**PERRYVILLE MUNICIPAL AIRPORT
CITY OF PERRYVILLE, MISSOURI**

ADDENDUM NO. 1

State Project No. AIR-11-063A-1

**BASE BID
AIRFIELD ELECTRICAL REHABILITATION,
SHOULDER REMOVAL AND GRADING
ADDITIVE ALTERNATE 1:
RUNWAY SAFETY AREA GRADING**

GRADING AND DRAINAGE
PLAN - RSA GRADING
SHEET 4 OF 7

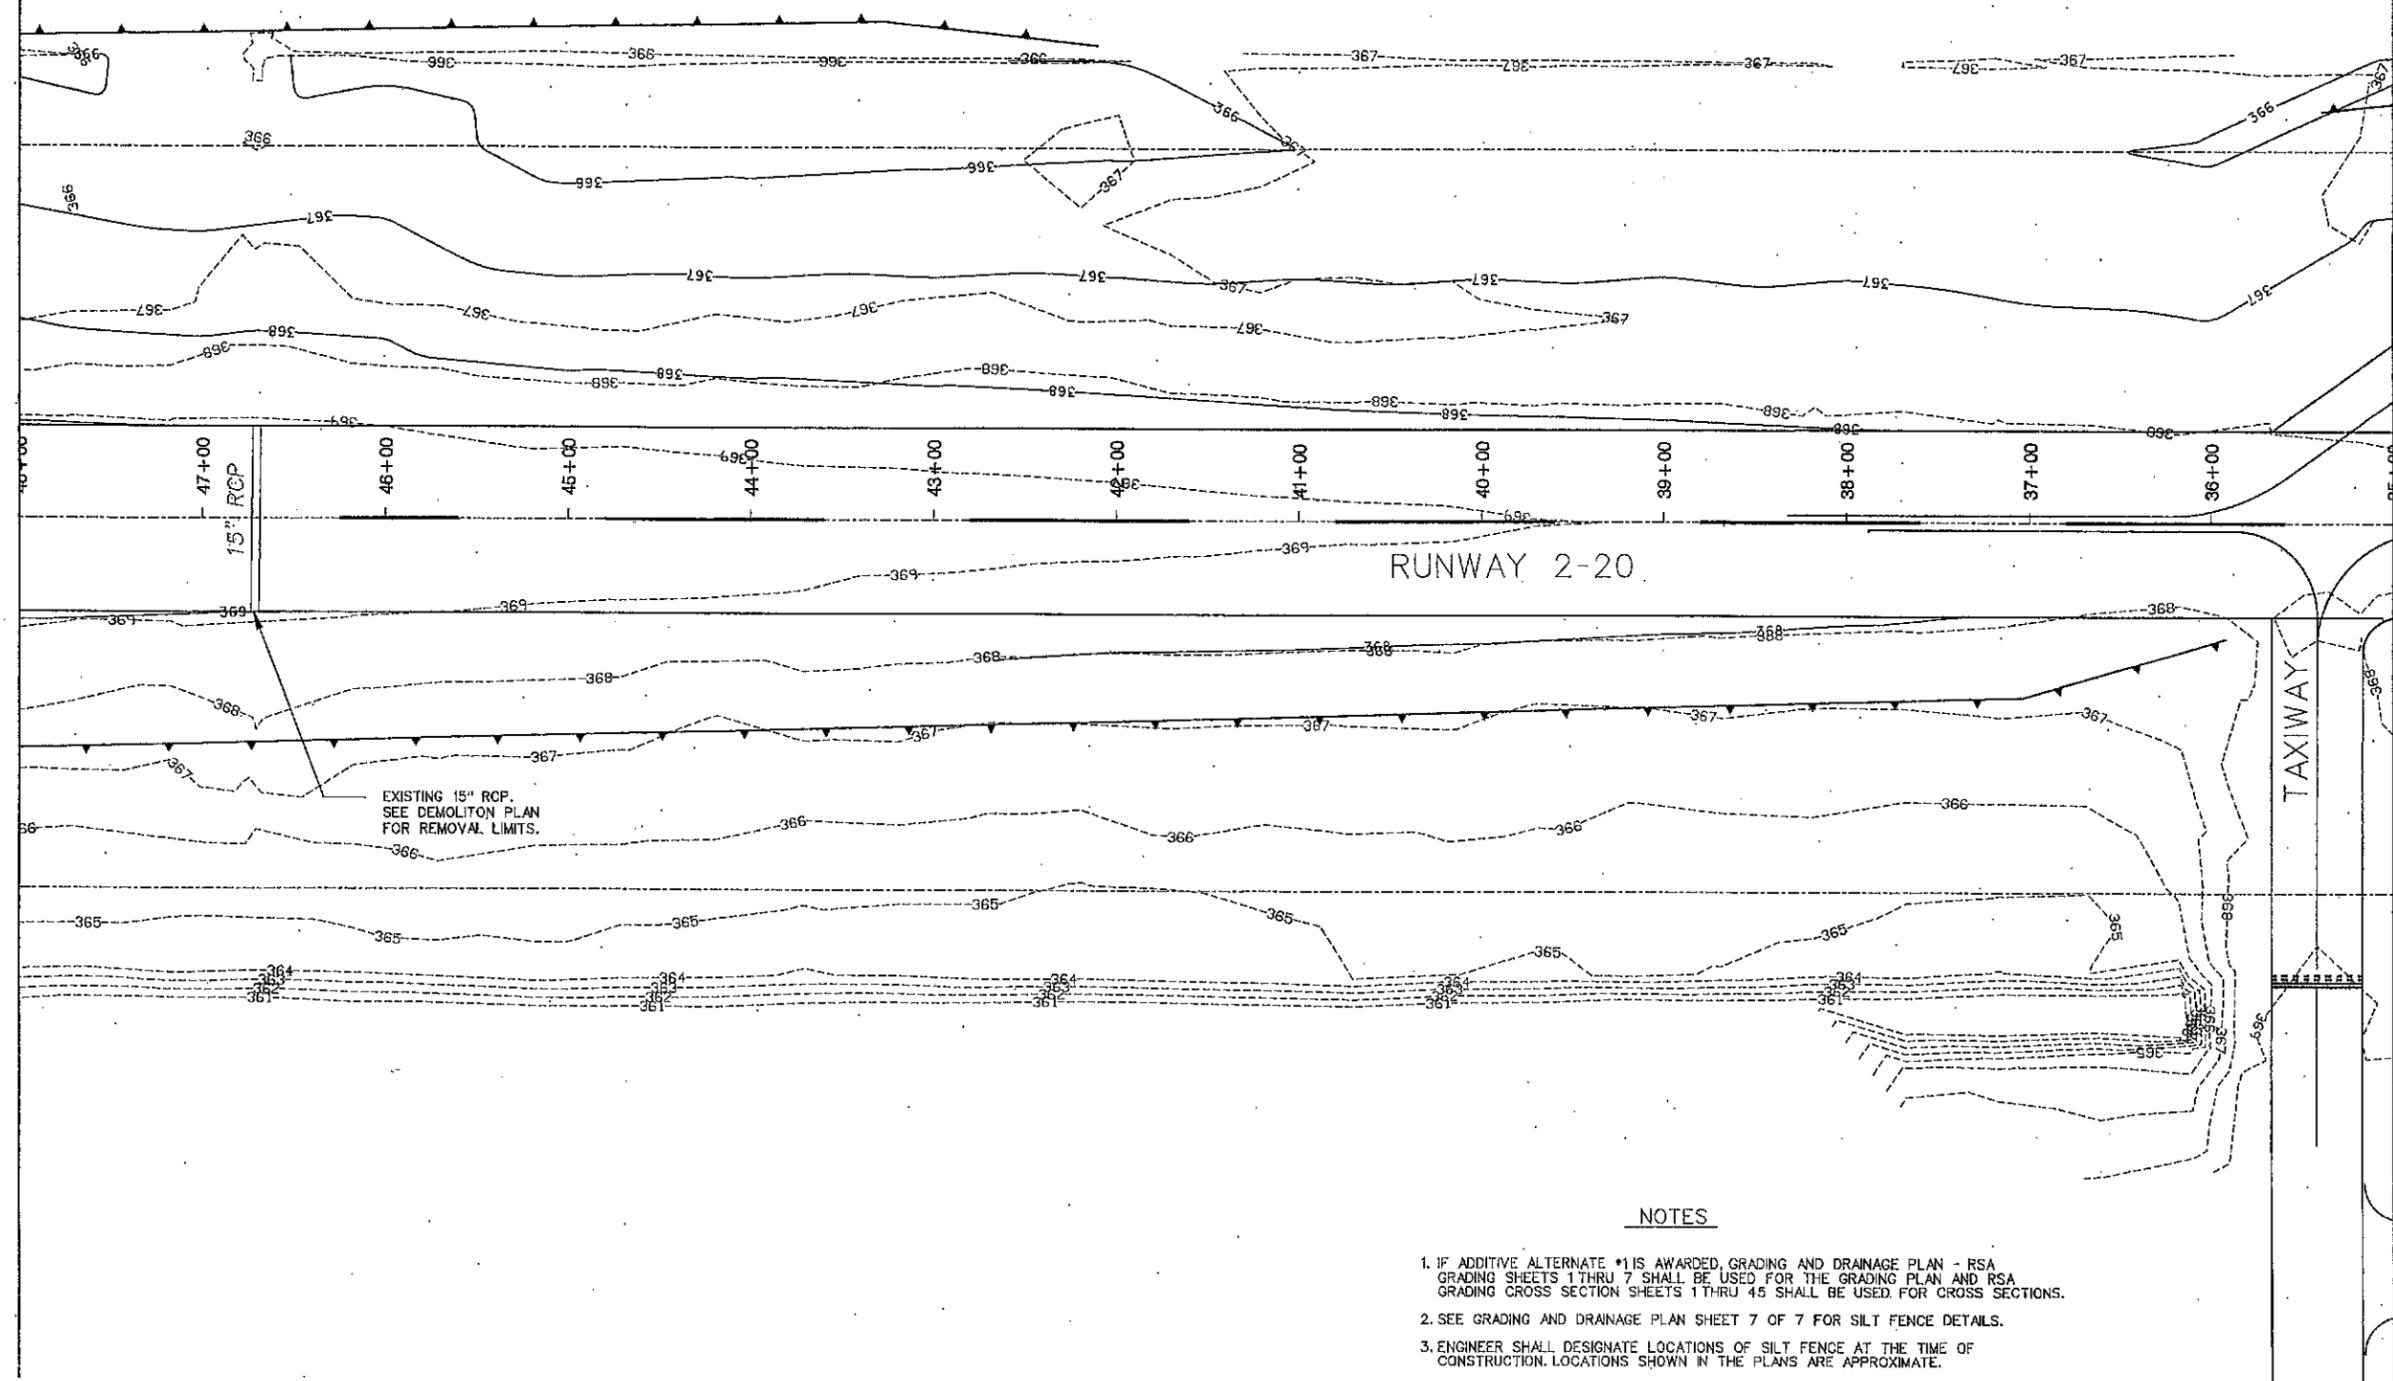
EXISTING 15" RCP.
SEE DEMOLITION PLAN
FOR REMOVAL LIMITS.

FILE: 28_grading_plan_6.dgn
DESIGN BY: TWM
DRAWN BY: TWM
CHECKED BY: TCS
APPROVED BY: TCS
DATE: JULY 5, 2012
JOB No: 1140105-00
GRADING AND DRAINAGE PLAN - RSA GRADING SHEET 6 OF 7
SHEET 28 OF 74 SHEETS

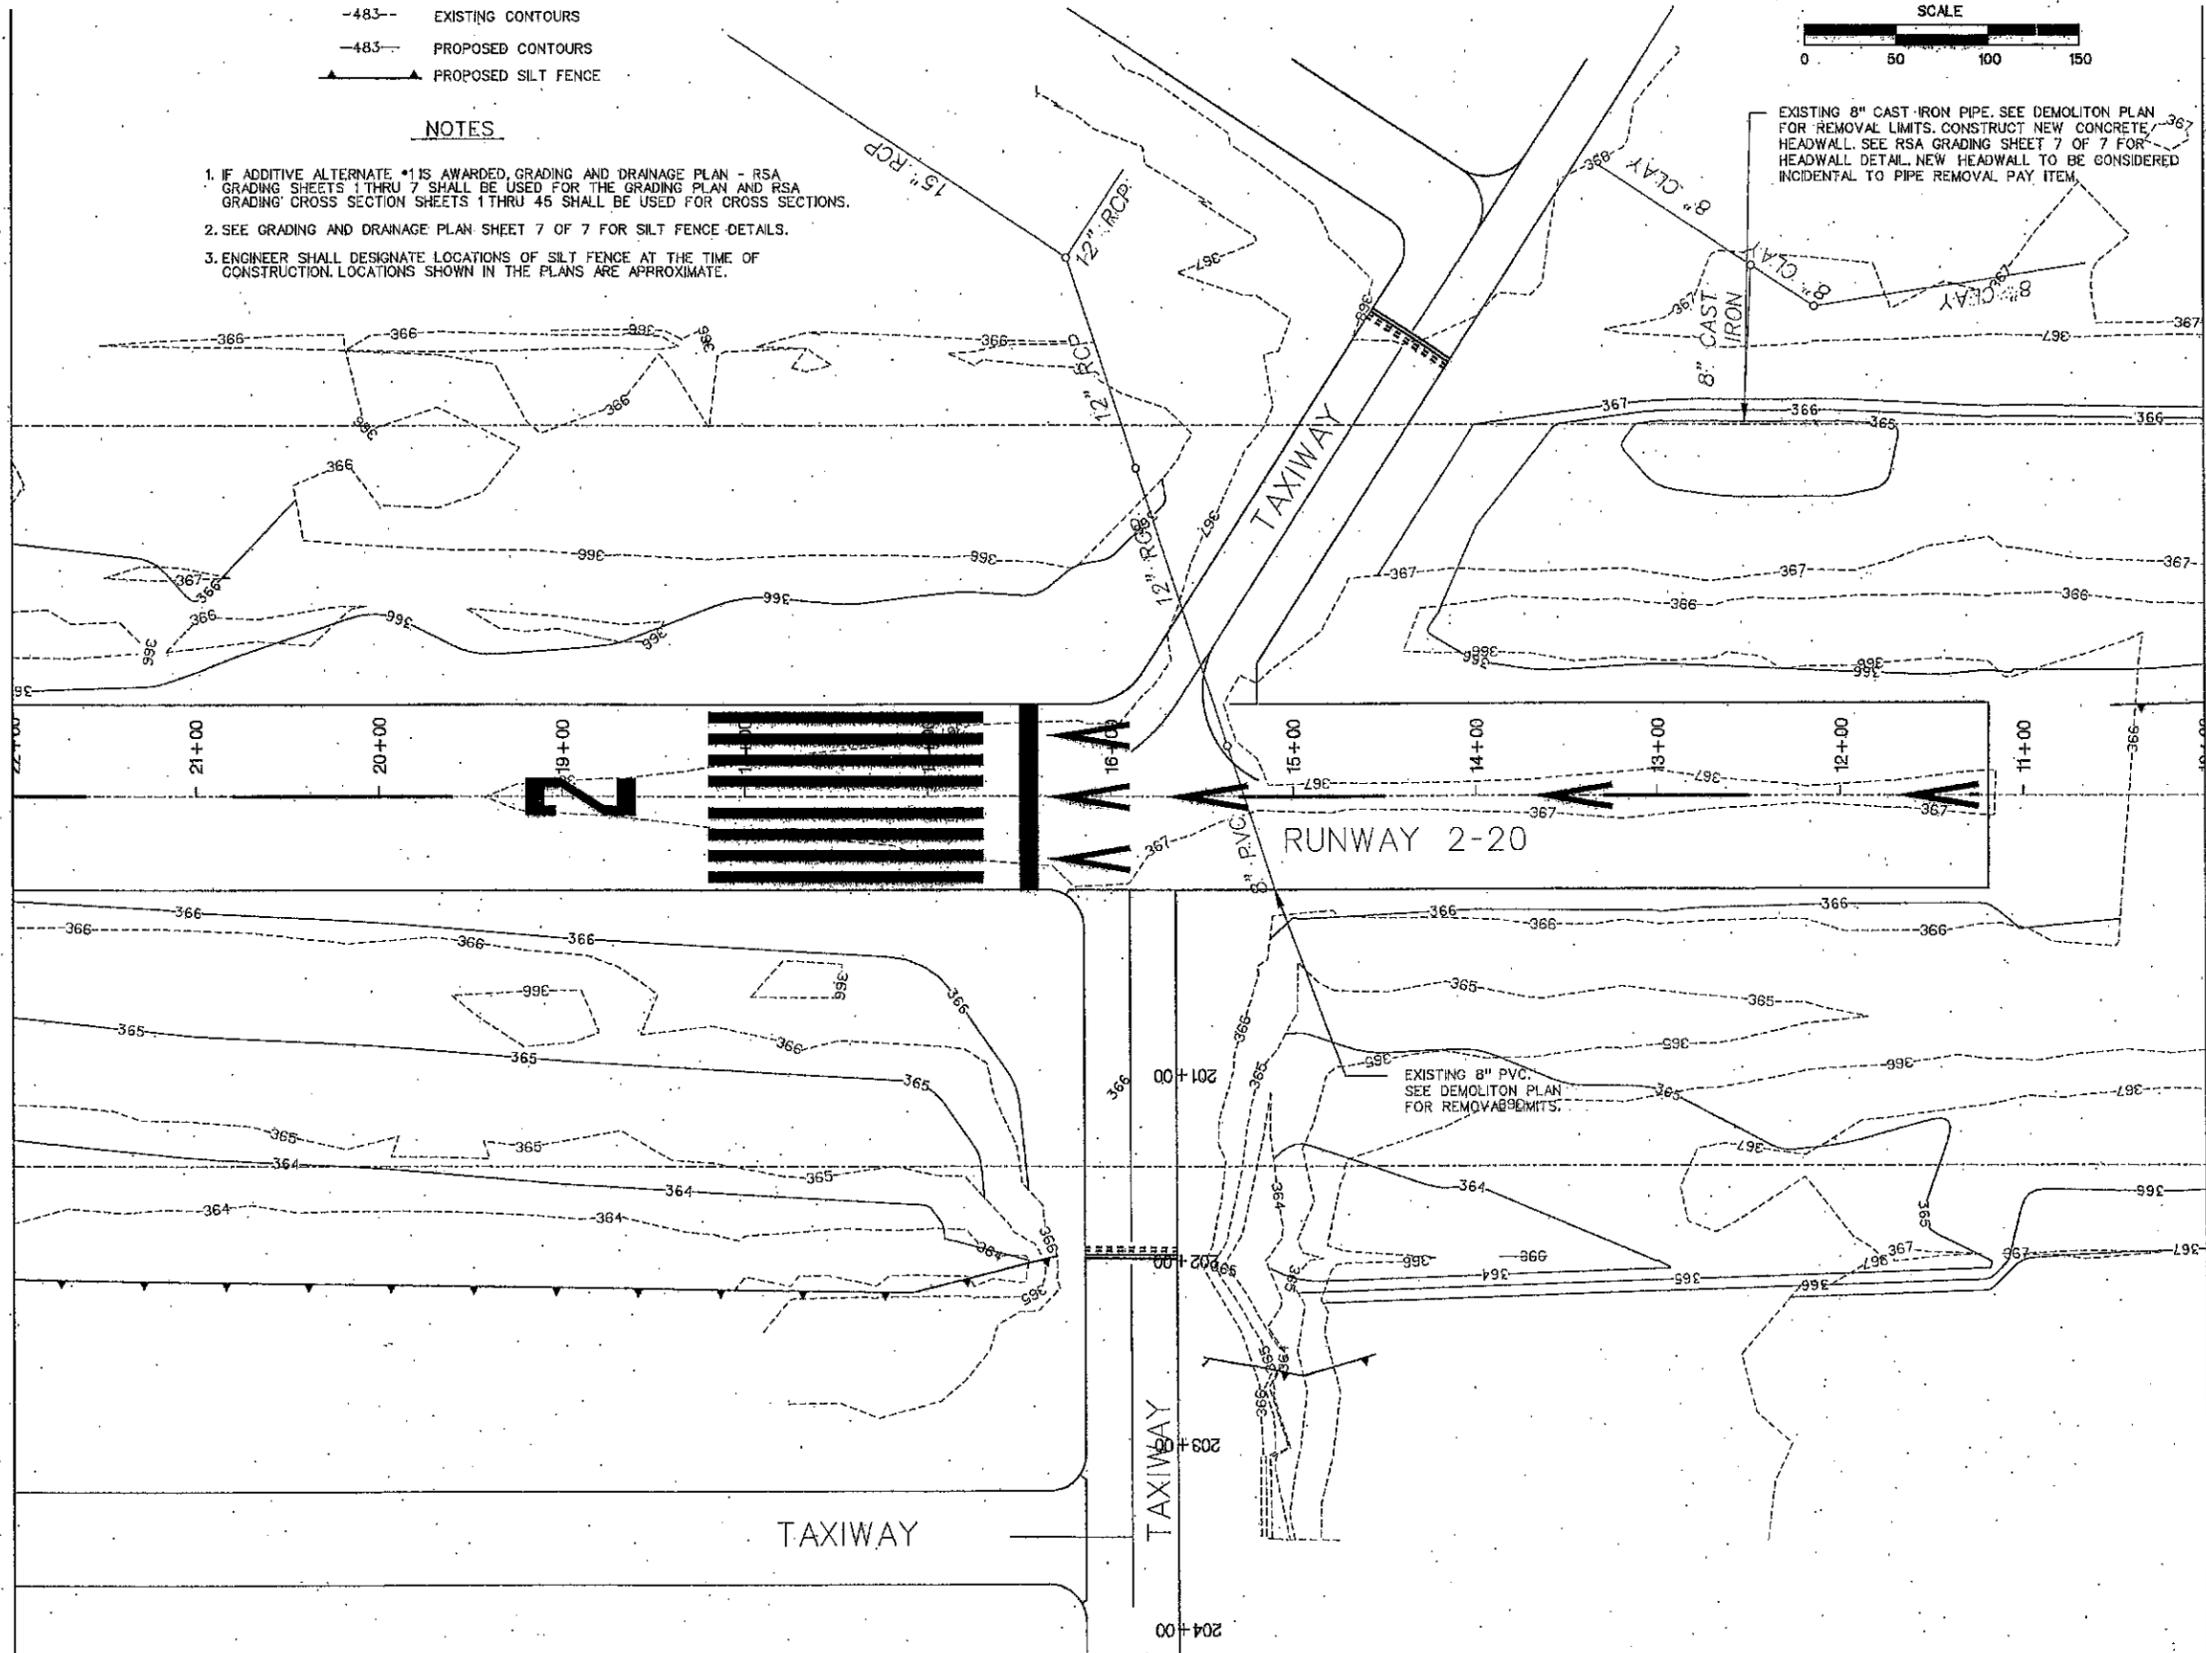
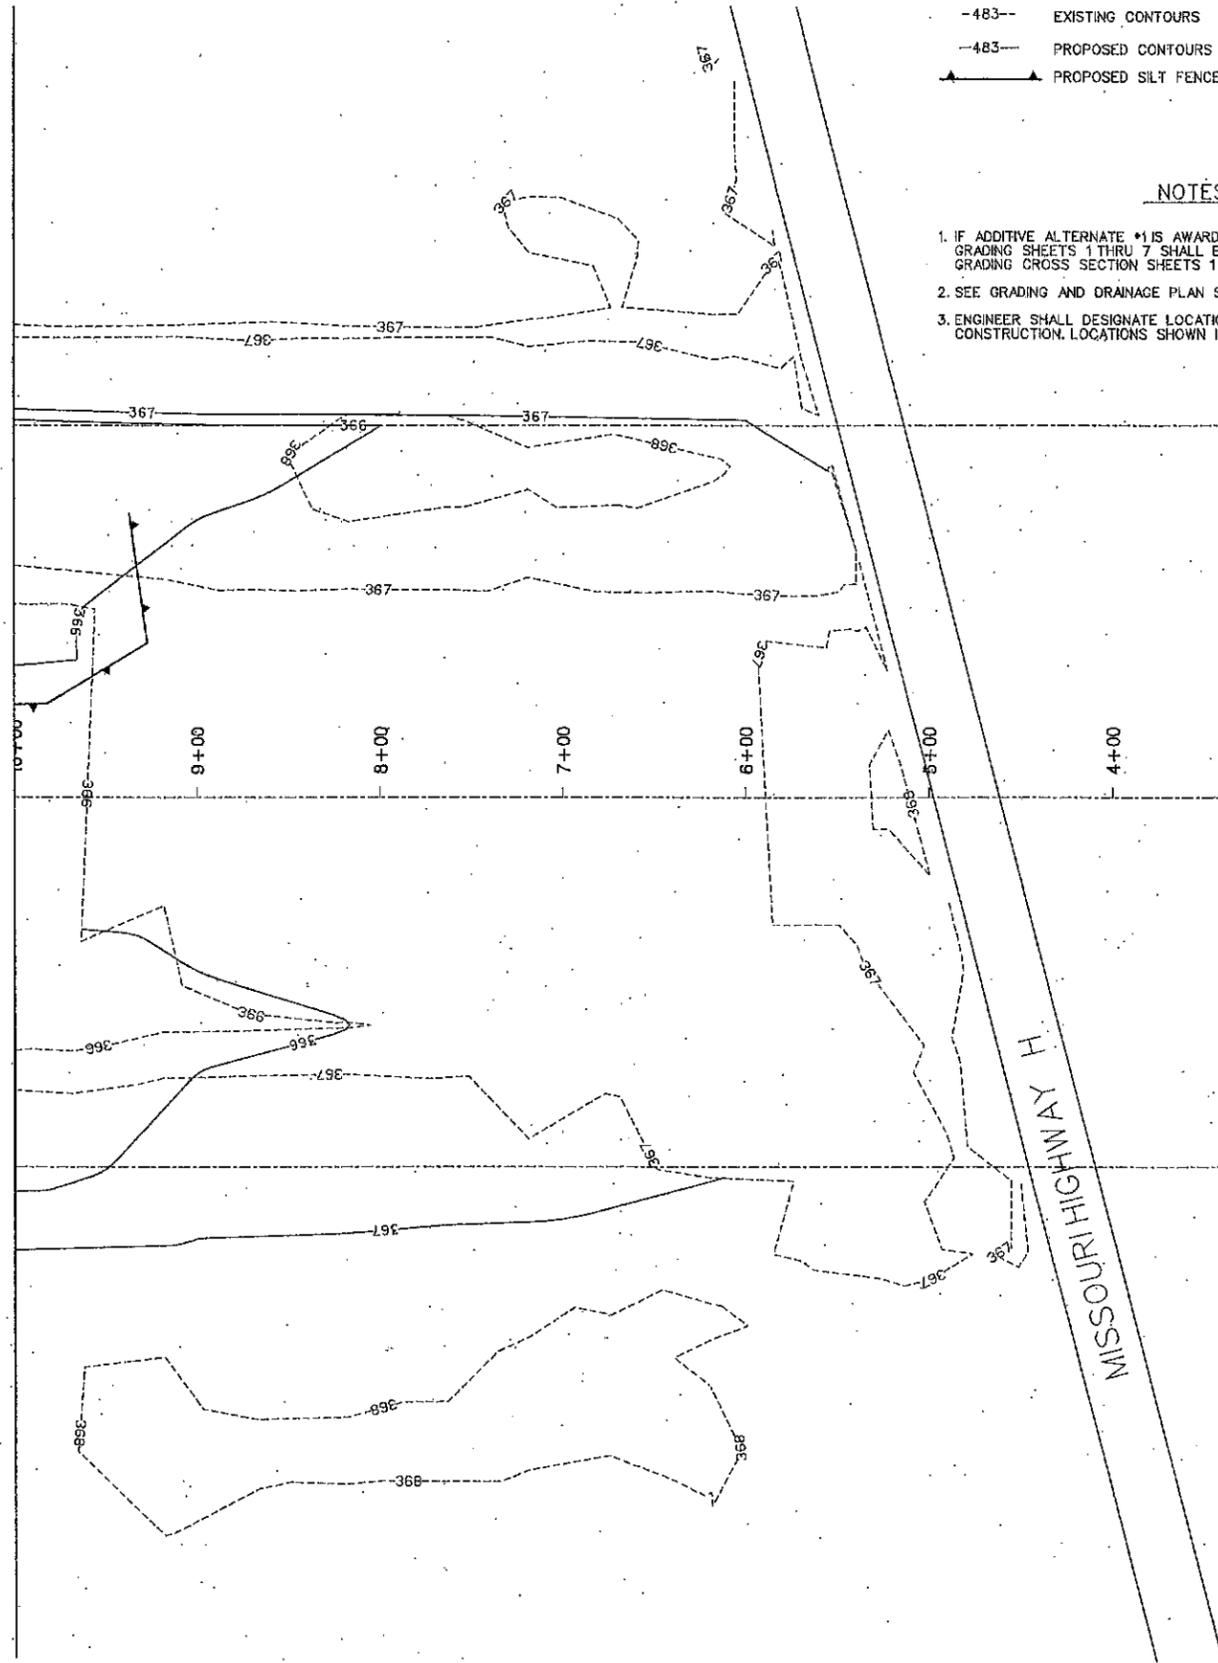
EXISTING 8" CAST IRON PIPE. SEE DEMOLITION PLAN FOR REMOVAL LIMITS. CONSTRUCT NEW CONCRETE HEADWALL. SEE RSA GRADING SHEET 7 OF 7 FOR HEADWALL DETAIL. NEW HEADWALL TO BE CONSIDERED INCIDENTAL TO PIPE REMOVAL. PAY ITEM.

EXISTING 8" PVC. SEE DEMOLITION PLAN FOR REMOVAL LIMITS.
